UNITED STATES PATENT AND TRADEMARK OFFICE

APPLICATION NO.	FILING DATE	FIRST NAMED INVENTOR	ATTORNEY DOCKET NO.	CONFIRMATION NO.
10/789,268	02/26/2004	Bradley R. Stager	P 0555.14107	9398
30615	7590	07/18/2006	EXAMINER	
BIRDWELL & JANKE, LLP 1100 SW SIXTH AVENUE SUITE 1400 PORTLAND, OR 97204			MILLER, BENA B	
			ART UNIT	PAPER NUMBER
			3725

Office Action Summary	Application No. 10/789,268	Applicant(s) STAGER, BRADLEY R.	
	Examiner Bena Miller	Art Unit 3725

DETAILED ACTION

Ward

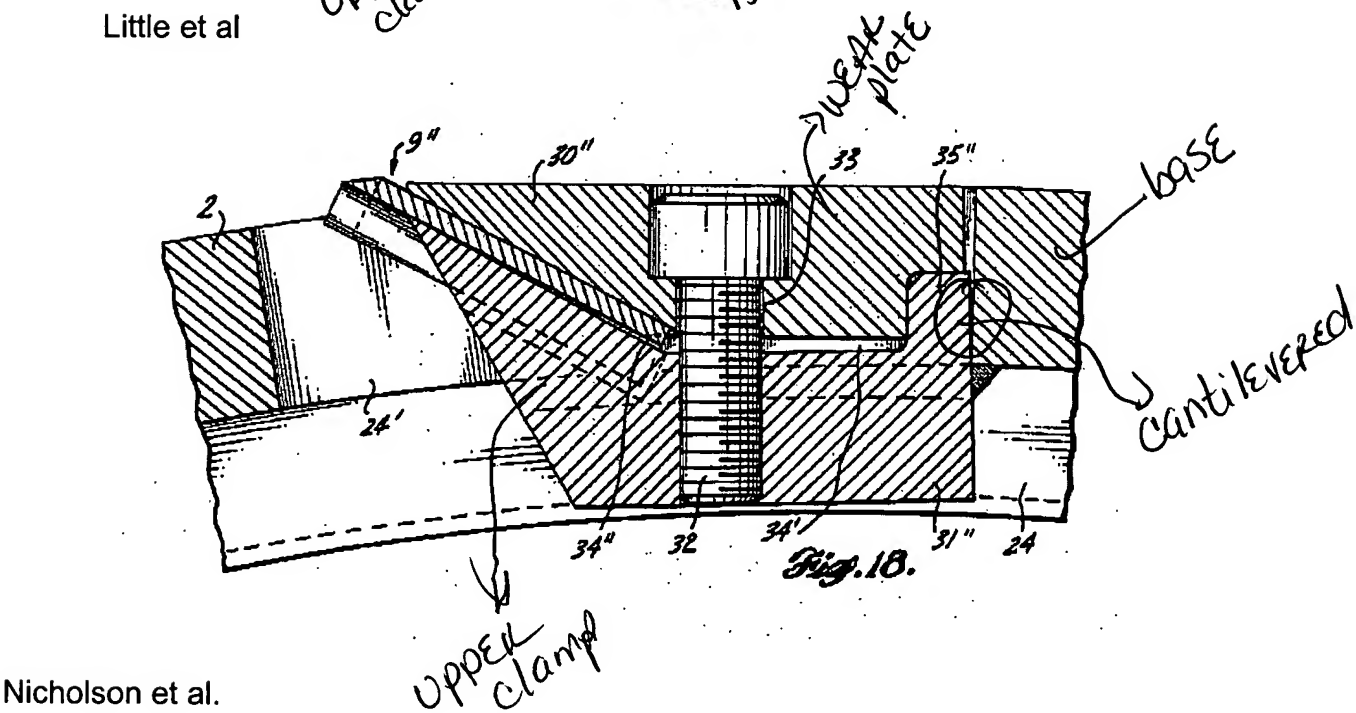
Claims 1 and 3-8 are finally rejected under 35 U.S.C. 102(b) as being anticipated by Ward (US Patent 3,322,175) or Little et al (US Patent 3,209,801) or Nicholson et al (US Patent 3,661,192) or Hansel et (US Patent 4,298,044).

The device of Ward or Little or Nicholson or Hansel reads on the elements of the claimed invention including a knife, a base, a wearshoe, an upper clamping member, the upper clamp member and wearshoe adapted for mounting engagement with the base to provide a gap between the first portion of the upper clamping member that is cantilevered from the base and the apparatus adapted for elastically deflecting the upper clamping member so as to close the gap as seen in the marked up figures below. Little et al further teaches the wearshoe and base including cooperatively interlocking portions wherein portions are adapted to prevent the movement of the base.

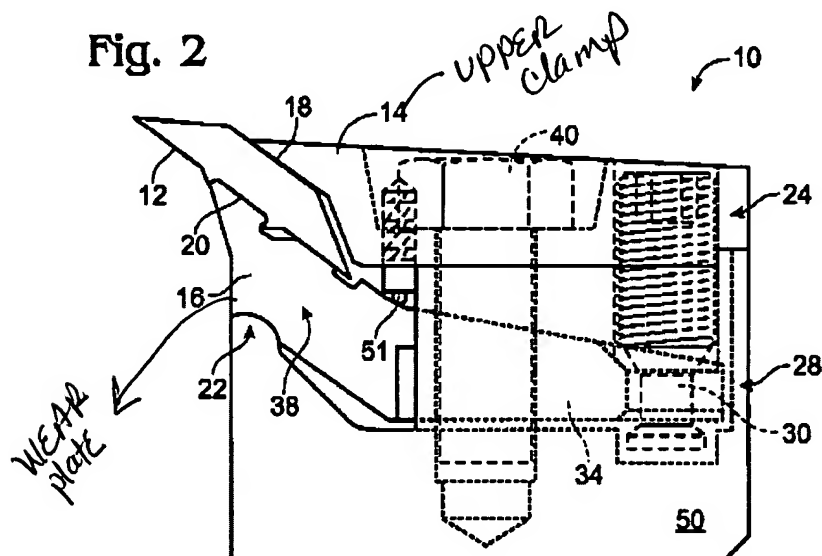
Claims 9-17 are finally rejected under 35 U.S.C. 103(a) as being unpatentable over Smartwood et al (US Patent 5,979,522) in view of either Dean (US Patent 4,972,888) or Loth (US Patent 6,561,885).

Smartwood teaches in the figures most of the elements of the claimed invention including a base, a upper clamping member and a wearshoe (combination of 34 and 16) as seen in the marked up copy. However, Smartwood fails to teach a ring assembly comprising two end plates. Dean or Loth both teaches wood chipping machine

including a ring assembly having two end plates (fig.3 of either Dean or Loth) for cutting chips. It would have been obvious to one having ordinary skill in the art at the time the invention was made to incorporate a ring assembly as suggested by Dean or Loth in the device of Smartwood for the purpose of cutting chips.
